Our Case Number: ABP-316119-23

Re: DART+ South West Electrified Heavy Railway Order - Hazelhatch & Celbridge Station to Heuston Station, and Hesuton Station to Glasnevin
County Dublin and County Kildare

Re: DART+ South West Electrified Railway Order 2023 (An Bord Pleanála ref. 316119)

Figure 1: Extract from Works Layout Plan No. 10 submitted with Dart+ South West Railway Order. Sites 4 and 5 being progressed for housing development by LDA & DCC highlighted in dotted red.

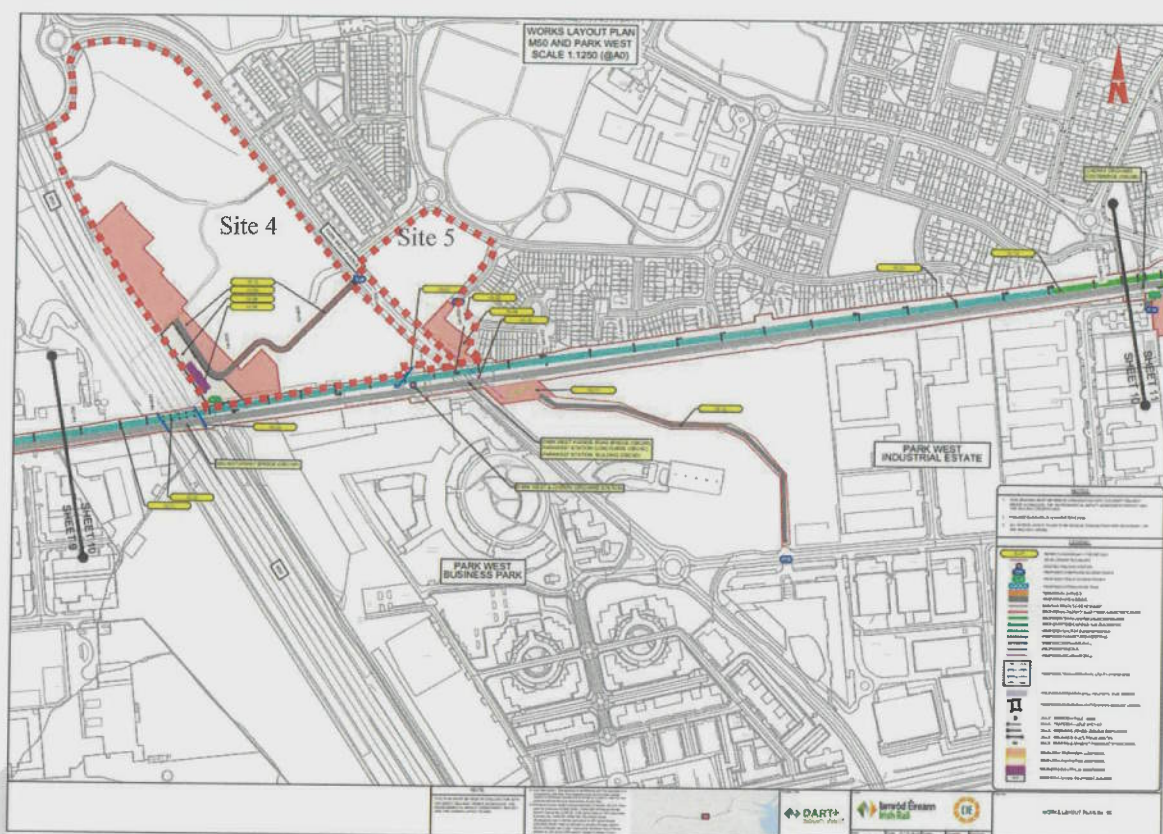
- 2.0 **Proposed temporary compound at Site 4**
- 2.1 Works Layout Drawing No. 10 submitted with the Railway Order shows a number of proposed works on the DCC/LDA Site 4. A proposed temporary construction compound is proposed along the west/south-west boundaries of Site 4 (Works No. 10.06). It is proposed that the temporary compounds will be required for the duration of the construction works/programme i.e. until 2029.
- 2.2 The LDA and CIÉ discussed and agreed the general location and size of the compound prior to submission of the Railway Order. This location will ensure the Phase 1 housing development site is not compromised. The LDA request that the location of the temporary compound as proposed on Works Layout Drawing No. 10 is retained as significant changes to this location will impact the LDA's mandate to deliver affordable housing at this site.

- 2.3 The LDA request that further consultation be carried out between LDA, DCC & CIÉ before and during the construction process to ensure the location of the temporary compound is appropriately located to ensure the construction of both projects can proceed with minimal impact to each other.

Figure 2: Suggested temporary landscaping to temporary Dart+ construction compound to Site 4 (Mitchell & Associates on behalf of LDA)

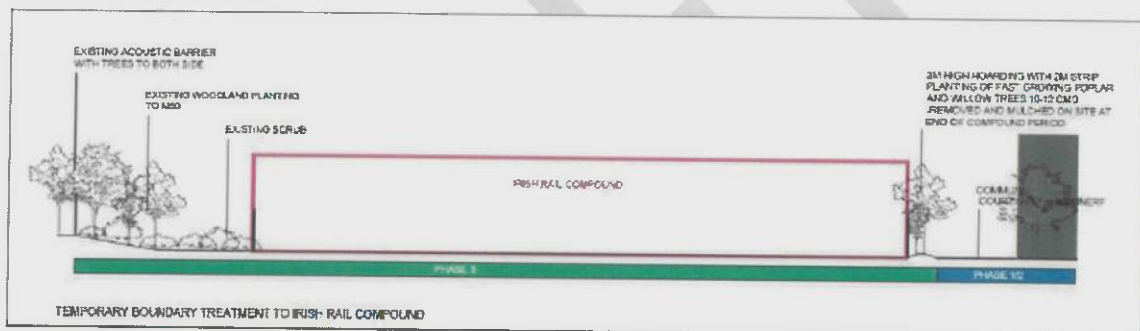
- 3.1 The temporary construction compound on Site 4 is to be in place for the duration of the Dart+ construction period (See Works No. 10.06 on Works Layout No. 10). As a result, it is likely that housing development proposed as part of phase 1 on Site 4 will be delivered in advance of completion of the railway works and will therefore be facing the temporary compound and construction hoarding. As a result, DCC and LDA would request that temporary landscaping on the outside of the compound hoarding be delivered to address the visual and noise impact likely to be caused to the phase one residential units. DCC/LDA request a high quality 3-metre-high hoarding with 2 metre strip of planting of fast-growing poplar and willow trees (10-12 cmg [Centimetre Girth]) be planted for the duration of the construction period and following this that they be removed and mulched on site at the end of construction.

Figure 4: Example of ESB 38V Twin Circuit Cross Section which will likely run through Site 4 roadway (Waterman Moylan on behalf of LDA).

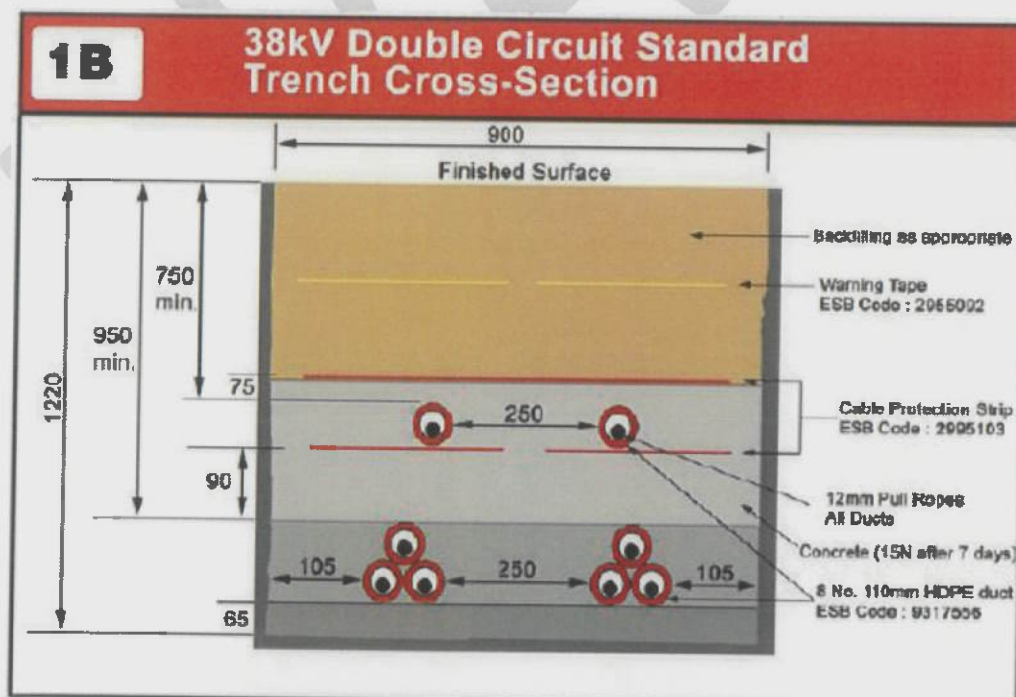
4.1 Works Layout Drawing No. 10 submitted with the Railway Order shows a proposed gravel access road to service the proposed Park West Substation Compound and temporary construction compound. The road is to include the substation electricity cable supply (38KV infrastructure) route (Works No. 10.14). The proposed road and cable route follows the line of the permanent development internal road network proposed as part of the forthcoming Phase 1 planning application at Site 4 proposed by the LDA and DCC. Given this proposed internal road will be subject to a forthcoming planning application, the LDA are seeking to ensure that further engagement with CIÉ and other necessary stakeholders be ensured throughout the construction period. The LDA seek to ensure that the location and routing of the proposed temporary access road and cable infrastructure route be co-ordinated between all relevant stakeholders to ensure both the Dart+ and residential led development at Site 4 can proceed without conflict.

4.2 On behalf of the LDA, Waterman Moylan, Consultant Engineers, have reviewed the information submitted with the Railway Order and understand the 38KV substation proposed on Site 4 to serve Dart+ South West will require a two-circuit network connection. The drawings submitted show the proposed substation to the south west of Site 4 at Park West and only a short section of ducting which is noted as "possible route of 2 x 38KV incoming supplies from ESB – To Be Confirmed" (See Drawing title Park West Substation Location Plan and Layout - DP-04-23-DWG-RO-TTA-18856). The ongoing route of the 38KV infrastructure will likely have to be provided through the DCC lands (Site 4) to extend as far as Park West Avenue. Furthermore, it would also suggest that additional ducting will have to be provided through existing roads beyond the ownership of CIE/Irish Rail. Waterman Moylan understand a twin circuit 38KV duct cross section will require a 900mm wide and 1200mm deep service trench through which other services will not be allowed to run (see example of service trench below in Figure 4). Other services may run alongside the 38KV twin circuit cross section, however. The LDA would request that the final alignment of the proposed electricity infrastructure routing follow the proposed road centreline in order to minimise impact on and allow space for additional necessary infrastructure to serve the overall development of Site 4.

Figure 5: Proposed planting options for substation boundary proposed by LDA and DCC (Mitchell & Associates)

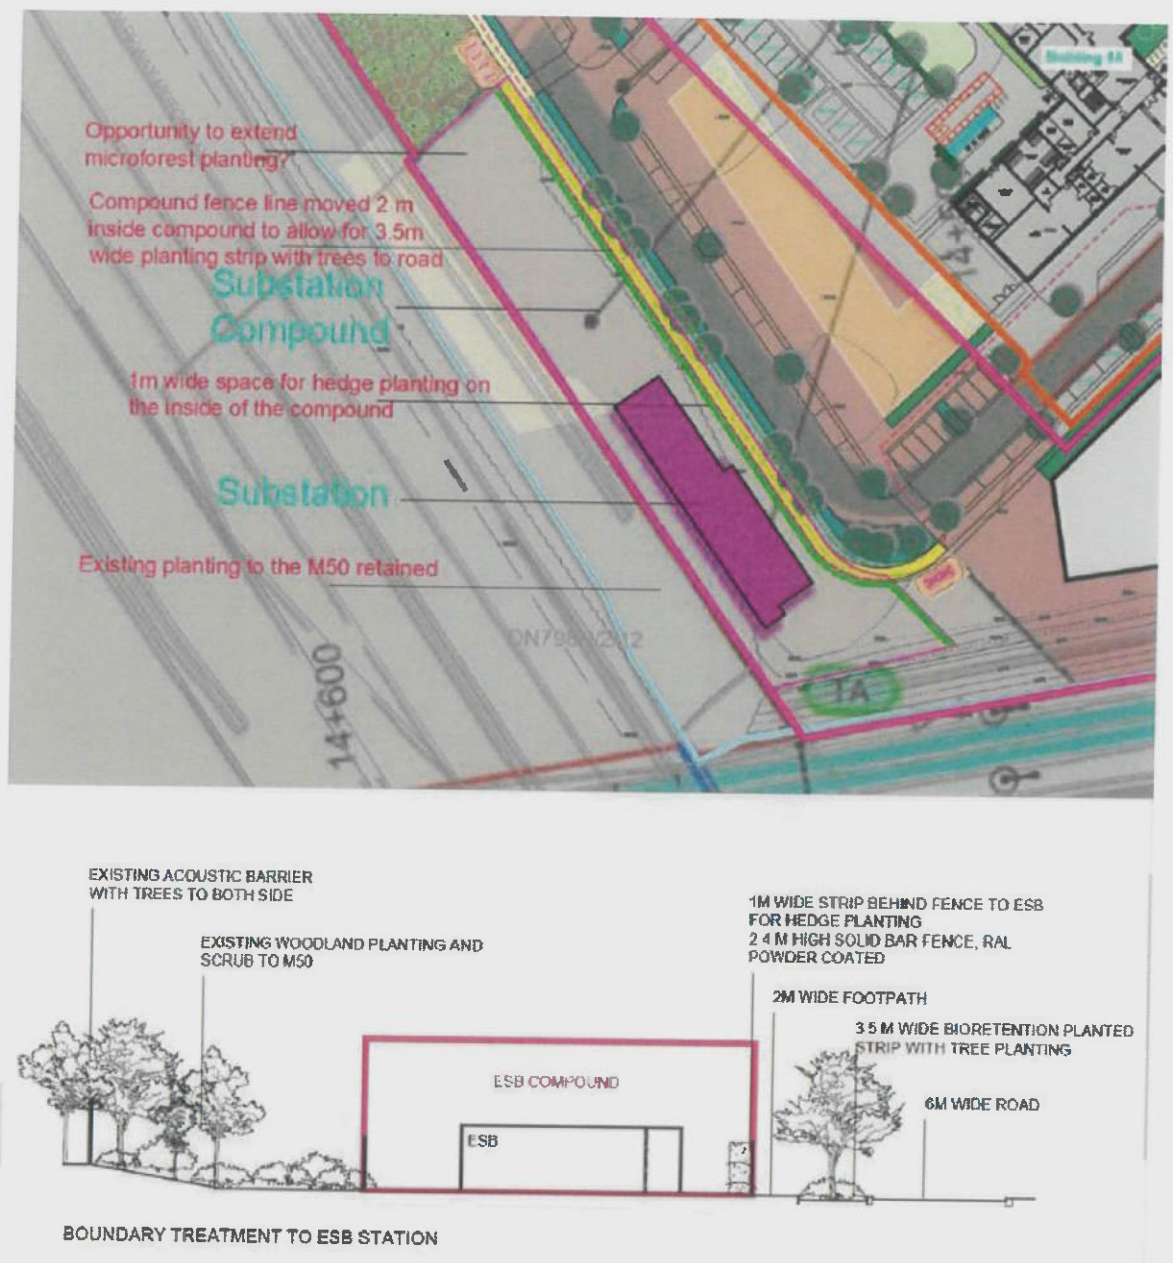
5.2 The LDA wish to make a number of comments regarding the proposed substation and permanent compound. Presently, the existing tree planting along the M50 within Site 4 provide a landscaped buffer to the site. The LAP also seeks a 'green buffer zone' along this boundary with the M50 as part of a 'green corridor'. The proposed substation will permanently remove some of the existing trees and hedgerows. The LDA would request that some form of permanent tree and/or landscape planting be proposed either outside or inside the eastern and northeastern boundary fences of the substation to ensure a landscape buffer is provided to Site 4. This will ensure the green buffer is provided as sought by the LAP and will mitigate the visual impact of the substation which will in future be located opposite housing and commercial development at Site 4. The following options are suggested (see Figure 5 for illustration):

Option 1: Consider moving the proposed boundary palisade fence 2 metres inside the ESB compound on the eastern side to allow for widening of the bio retention planting strip to 3.5 metres to accommodate tree planting to mitigate the visual impact of the compound and loss of existing trees in that zone.

Option 2: If no opportunity for planting within compound area, consider at least a 1 metre wide planting space along the fence line to the inside of the compound to allow for hedge planting (hedge to be planted on the inside of the compound to prevent people from climbing on the hedge and over the fence).
